STAFF REPORT WEST ALLIS PLAN COMMISSION Wednesday, June 26, 2019 6:00 PM

- 2A. Application for Special Use Permit for proposed new construction of a behavior health hospital to be located at 1706 S. 68 St. and adjacent commercial parking lot at 1700 Block S. 68 St.
- 2B. Site, Landscaping and Architectural Plans for a proposed new construction of a behavior health hospital and off-street parking to be located at 1706 S. St. and adjacent commercial parking lot at 1700 Block S. 68 St., submitted by Brian C. Randall, Davis & Kuelthau, s.c. on behalf of Milwaukee Behavior Health, LLC c/o Diane Henneman of Universal Health Services. (Tax Key No. 453-0776-003 & 453-0747-001)

Conceptual Rendering - View 05

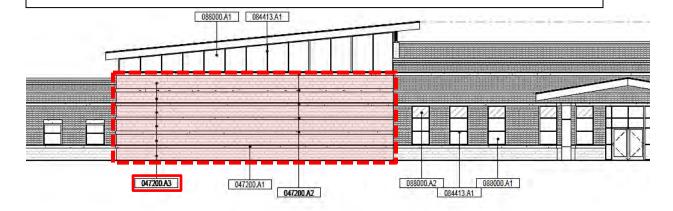
- Staff is recommending brick or an alternate to the proposed split faced veneer material on the west elevation of the gymnasium portion of the building.
- Window transparency detail being indicated on the north elevation of the main entrance.
- Color details of the exterior materials being provided.

Elevation labels being updated

Highlighted - Area recommended for brick or an alternate to the proposed split faced veneer shown (west elevation of the gymnasium portion)
